Submission to the CNSC on CNL's Draft Environmental Impact Statement

Re: Nuclear Power Demonstration Closure Project (Ref No. 80121)

February 13, 2018

Figure G-9. Release of Radionuclides from Reactor Vault to Boiler Room

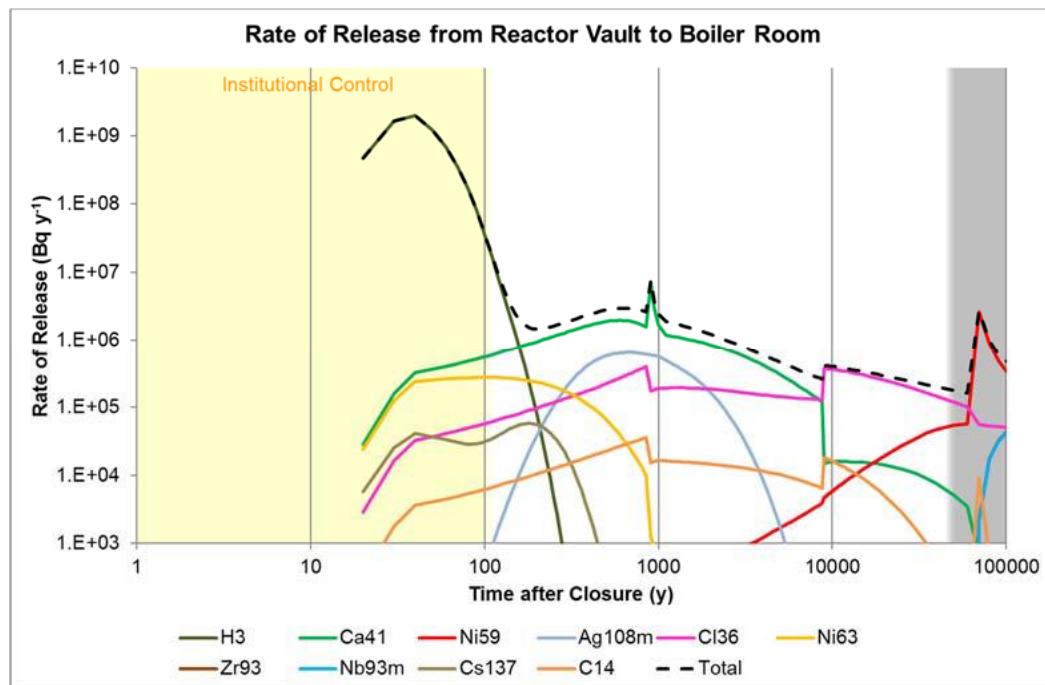
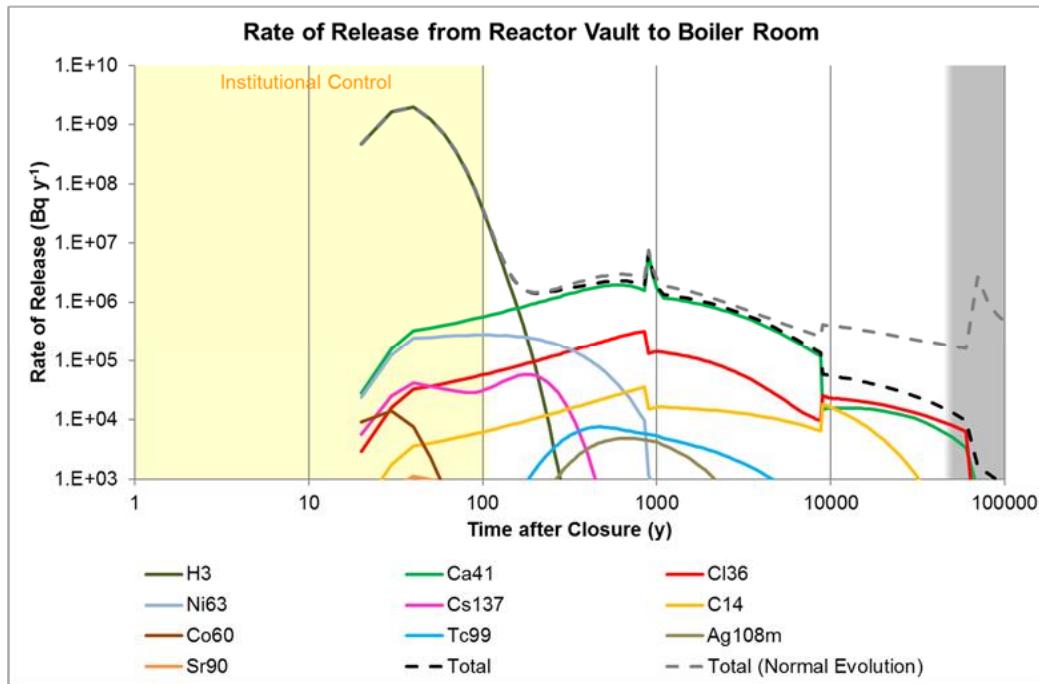
Since the publication of the draft EIS, however, CNL has indicated in its Post-Closure Safety Assessment report that the calandria may be removed before entombment and not form part of the waste inventory at the NPD site. It is uncertain whether CNL intends to remove the calandria immediately during decommissioning or defer its removal to a later date. The alternatives means analysis does not provide insight into which strategy might be preferable and it is unclear whether CNL has in fact undertaken any relative risk assessment on the matter.

While the removal of the calandria eliminates some long-lived nuclides (though not C-14 and tritium) there are few net savings as illustrated by Figures G-9 and G-70 reproduced below from Appendix G of the Post-Closure Safety Assessment report. While there may be little difference between rates of release (with the exception of some nuclides 800 to 1000 years post-closure), what these figures do not capture is a comparison of worker radioactive exposures and doses, the availability and options for off-site disposal, and intergenerational and future ecosystem impacts.

The concerns that must be weighed in determining whether the calandria should remain on site or be removed as soon as reasonably possible, include considerations such as:

- Based on the radiological inventory of the calandria, wouldn't worker dose level remain largely the same even after deferring the calandria's decommissioning?
- Would there be any capacity to decommission and remove the calandria in 100 to 300 years? Likewise, would the expertise, or funding exist?
- Regardless of the benefits of deferring, would removal of the calandria reduce the relative risk to the Ottawa river?
- A comparison of CNL's figures G9 and G70 in Appendix G of the Post-Closure Safety Assessment report indicate there is little difference between either strategy with respect to release of radionuclides, except for lower amounts of some nuclides 800 to 1000 years post-closure.
- While deferring removal would eliminate some long-lived radionuclides, would removal result in an overall benefit?
- What are the costs associated for each strategy?
